JMT Consulting has been commissioned by the University of New South Wales (UNSW) to prepare this document in response to the issues raised in by government agencies, community organisation groups and the public during the public exhibition of the proposed UNSW Health Translation Hub (HTH) State Significant Development (**SSD**) application (SSD-10822510).

This document has been prepared to respond to the transport related issues raised by Transport for NSW and Randwick City Council as reproduced on the following pages.

Concept design road safety audit

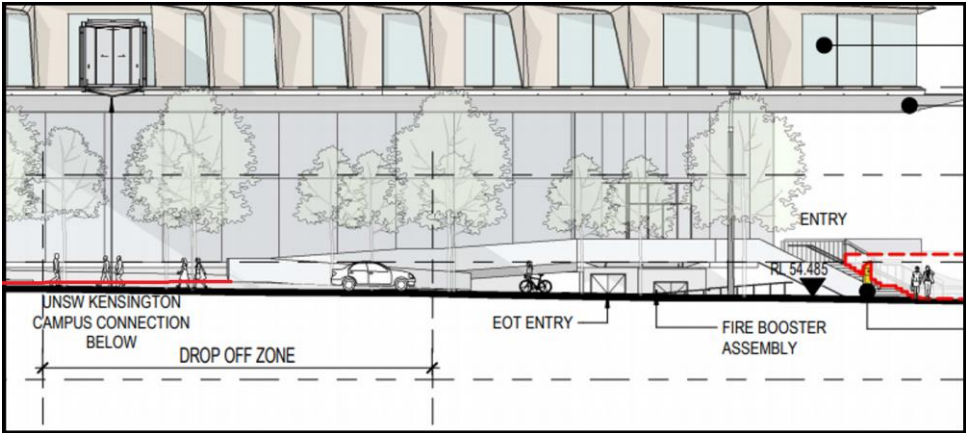
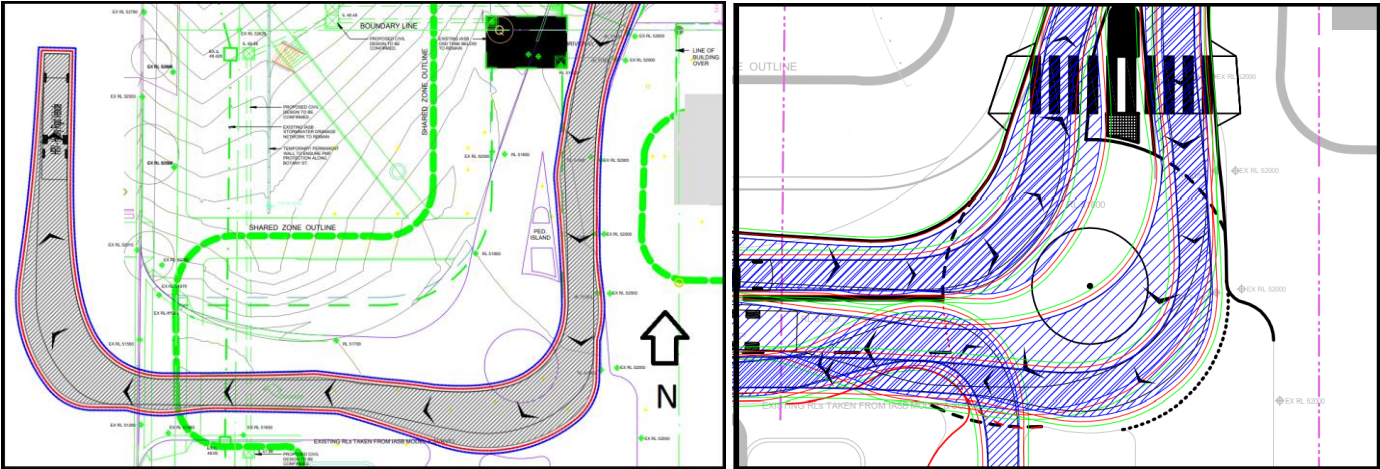
Ref	Location	Road safety audit finding	Priority
1	UNSW Campus Connection bridge.	<p>The design includes a pedestrian bridge over Botany Street to link the HTH to the Wallace Wurth Building. This appears to be exclusively for patrons of the HTH and the Wallace Wurth Building, to enable these pedestrians to cross between these buildings without using the roadway. The audit team questions why this bridge cannot be made more accessible to other members of the public. This also includes other patrons of both sites that may not come from the required floors of the building, eg. pedestrians in the UNSW Plaza area, from the bus zone or from the ground level facilities in the HTH.</p> <p>A more publicly accessible bridge would offer a grade separated road crossing facility that eliminates the <i>vehicle-pedestrian</i> crash conflict. The alternative for ground-level pedestrians is to walk 60m north to the signalised crossing at the High Street intersection, or 100m south to the signalised intersection at the vehicle access to HTH. As both of these signalised crossing points are considerable distances in each direction, the audit team envisages a high degree of non-compliance, with pedestrians likely to jaywalk between the two sides of Botany Street in uncontrolled midblock locations.</p>  <p>Above: The design includes a bridge connection between the HTH and the Wallace Wurth Building. However, this does not appear to allow for public access. Rather, it appears to be exclusively for patrons of the HTH and Wallace Wurth Building. This is a missed opportunity to improve safety and amenity for all pedestrians.</p>	Medium

Ref	Location	Road safety audit finding	Priority
2	Botany Street intersection with Gate 11 and the HTH access.	<p>The Transport Report indicates that the Botany Street intersection with Gate 11 of UNSW and the HTH will be traffic-signal-controlled. Although the civil and traffic signal designs for this intersection were not provided to the audit team, there are several high-level road safety issues that are evident. These include:</p> <p><u>Opposing right-turn movements from Botany Street:</u> There does not appear to be sufficient width in Botany Street to allow concurrent and opposing right-turn movements, ie. northbound right-turns into HTH and southbound right-turns into Gate 11. If spatial clearance is not achievable, this could result in <i>head-on</i> crashes between opposing right-turning vehicles. Alternatively, the northbound and southbound right-turns would need to be managed by split phases* which is counter-productive and delay-inducing.</p> <p><u>Short stacking in the HTH leg:</u> The length between point A and B in the left-hand image is approximately 35m. Although the traffic volume demands into and out of the HTH leg would not be significant (negligible on-site parking is proposed), there could still be situations where the queue at the traffic signals spills back towards point B and blocks the roundabout. For example, if several trucks egress at the same time. This risk is exacerbated as the channel A-B only includes one outbound lane with more risks of queuing, especially if egressing vehicles wish to turn right or proceed straight through the intersection to UNSW.</p> <p><u>Right-turn on pedestrian crash conflicts:</u> If filtered right-turns are allowed from the northbound direction of Botany Street to the HTH, this could present risks of <i>right-turn on pedestrian</i> crashes. This is irrespective of whether red signal/ arrow holds are used to safeguard pedestrians and cyclists crossing at point A (the Transport Report indicates that there would be a shared path on this side of the road). The risk is exacerbated since the northbound driver would tend to look to the north to judge gaps in the southbound traffic stream. By doing so, the same driver may fail to notice pedestrians/ cyclists crossing the driveway leg.</p> <p><u>Left-turns into and out of the HTH leg:</u> With limited width in the Botany Street legs to the intersection, there may be difficulty performing left-turns into and out of the HTH, especially by long vehicles. The swept path modelling provided to the audit team suggests that 12.5m rigid trucks would be required to commence the left-turn from the inside lane (lane 2). However, even smaller vehicles may not be able to perform this left-turn. As a comparative example, the right-hand photo shows a left-turning van from Gate 11 of the UNSW under existing conditions. Note how the vehicle crossed the centreline to perform this turn.</p> <p>Overall, these issues (along with many others) would need to be checked at the detailed design stage when civil and traffic signal designs are prepared.</p> <p>* Split phase operations involve an <i>all northbound</i> phase (including right-turns) followed by an <i>all southbound</i> phase (including right-turns) since the opposing right-turns cannot run concurrently. This typically increases intersection delays and queuing.</p> <div>   </div> <p>Left: The layout of the Botany Street/ Gate 11/ HTH access as presented in the architectural plans.</p> <p>Right: Looking northbound along Botany Street under existing conditions. Note how the left-turning van from Gate 11 needed to cross the centreline to complete this turn.</p>	Medium

Ref	Location	Road safety audit finding	Priority
3	Eastern side of Botany Street – Legibility of cycleway.	<p>The design indicates that there will be a cycleway provided on the eastern side of Botany Street. The audit team notes the following issues:</p> <ul style="list-style-type: none"> The entire cycleway is lined with trees. If these trees are indeed planted at these locations, they would pose as obstructions to bicycle movements. This could result in <i>bicycle-tree</i> impacts. Alternatively, even if placed immediately adjacent to the cycleway, the trees may pose as sight line obstructions to pedestrians. That is, pedestrians that are visually obscured by the trees could emerge suddenly into the path of an unwary cyclist. Similar to the trees, there are also a number of streetlighting poles along this cycleway. These would also pose as obstructions. There is no obvious method for cyclists to enter the cycleway from the northern end near High Street. This may result in cyclists entering from the kerb ramp which is meant for pedestrians (see green arrow in left-hand image). There would be risks of impacting pedestrians waiting to cross the road as well as potential impacts with traffic signal posts. The black and white hatched area in the left-hand image is a bus zone, which will presumably include a bus stop. Any bicycle movements along the marked cycleway could result in impacts with pedestrians either waiting for a bus, or boarding/ alighting a bus. At the HTH drop off bay, the cycleway terminates at point X (right-hand image) and then recommences at point Y on the other side of the bay. It is unclear how the cyclist is to move from point X to Y. Some cyclists may believe that they are meant to enter the roadway. This would present risks of impacts with/ by road vehicles including those in the drop off bay. Also, there are no kerb ramps shown to allow safe movements over these two kerb lines. If cyclists veer around the drop off bay, they could endanger pedestrians on this portion of the path. Although this is intended to be a shared path, cyclists typically ride faster on dedicated cycleways compared with shared paths. It should also be noted that this portion of the path is downhill in the southbound direction (ie. in the direction of the cyclist). Further to the previous point, any veering movement around the drop off zone could result in bicycle impacts with pedestrians or opened doors of vehicles in the drop off bay. Towards the southern end, the cyclists may also be at risk of running into opened doors of vehicles parked in the 1-hour parking spaces. <div style="display: flex; justify-content: space-around; align-items: flex-start;">   </div> <p>Left: It is unclear how southbound cyclists are to access the cycleway. If they use the kerb ramp at the pedestrian crossing (green arrow) this could endanger pedestrians waiting to cross the road. Right: It is unclear how cyclists are to move from the terminated cycleway at X to the recommencement of the cycleway at Y.</p>	Medium

Ref	Location	Road safety audit finding	Priority
4	Accessibility ramp from eastern side of Botany Road to the south-eastern corner of the HTH building.	<p>The design proposes a ramped connection from the street level to the south-eastern corner of the HTH building. This includes one return/landing. The audit team notes the following issues:</p> <p>The ramp is likely to be used by mobility-impaired pedestrians, particularly those dropped off at the indented drop off parking bay adjacent to the ramp. However, from the drop off bay, the pedestrian would need to travel downhill first, only to travel up the 1V:14H ramp grade. If the lower branch of the ramp was realigned to the north (as per the green arrow), a more level ramp could be achieved with the same length since the ramp would commence from higher ground. Also, there is less redundancy since the pedestrian does not need to go downhill before going up-ramp. The right-hand image attempts to illustrate this with the red line. This line is the same length as the lower branch of the ramp, only it faces north instead of south. Note how the ramp achieves a much more level grade. In fact, if the entire ramp was made to face north, it may even be possible to achieve a ramp without any upwards incline at all (or at least a substantially reduced upwards gradient).</p> <p>If the lower branch of the ramp is realigned to face north, the drop off bay should be relocated to the north accordingly. This would enable mobility-impaired pedestrians from all parts of the drop off zone to access the ramp in a downhill run.</p> <div style="display: flex; justify-content: space-around;">   </div> <p>Left: The design proposes a lower branch of the accessible ramp which returns 180° to the south (see yellow star). This ramp chases the grade and also invokes a redundant downhill movement to the base of the ramp only for the pedestrian to travel up-grade on the ramp. The ramp could be realigned to face north. Right: If the ramp was realigned to face north, it would be almost level and much easier to negotiate, particularly by mobility-impaired pedestrians.</p>	Low

Ref	Location	Road safety audit finding	Priority
5	Roundabout for access to Botany Street, the HTH basement, Sydney Children's Hospital (SCH1/CCCC) and Integrated Acute Services Building (IASB) project.	<p>The images below are extracts from the swept path model for a 12.5m rigid heavy vehicle egressing from the site. As shown, the truck is required to track over the central island of the roundabout that provides access to HTH, SCH1/CCCC and IASB. Seeing that most vehicle movements to the HTH basement will be loading vehicles (either utes, vans or trucks), the audit team questions whether a roundabout is really the most optimal solution. With all outbound trucks, and presumably most inbound trucks needing to mount over the central island, this would be a major inconvenience, even if the central island is fully mountable. The frequent movements over the island would also incur more pavement damage and the tyre marks would be unsightly and require routine cleaning. An intersection control allowing the trucks to remain on level ground throughout these turns may be a more viable solution. Additional speed reduction mitigations could be considered to compensate if the revised intersection fails to achieve the same speed reduction as a roundabout.</p> <p>The audit team adds that it is acceptable for trucks and other long vehicles to mount and track over the central island of a roundabout, if these are relatively rare and special cases. In most applications where this happens (eg. a mountable roundabout on a bus route), most vehicles are able to track completely around the central island without encroaching into it. It is only the occasional long vehicle (eg. bus) that needs to track over part or all of the roundabout island. However, in this scenario, since the vast majority of loading vehicles will need to track over the central island, it is not considered appropriate as the default access-egress method.</p>  <p>Above: The swept path models indicate that long vehicles (such as 12.5m trucks) would need to track over the central island of the roundabout. Since this represents a large proportion of the vehicles accessing the HTH basement, the audit team questions whether this is the most optimal design solution.</p>	Low
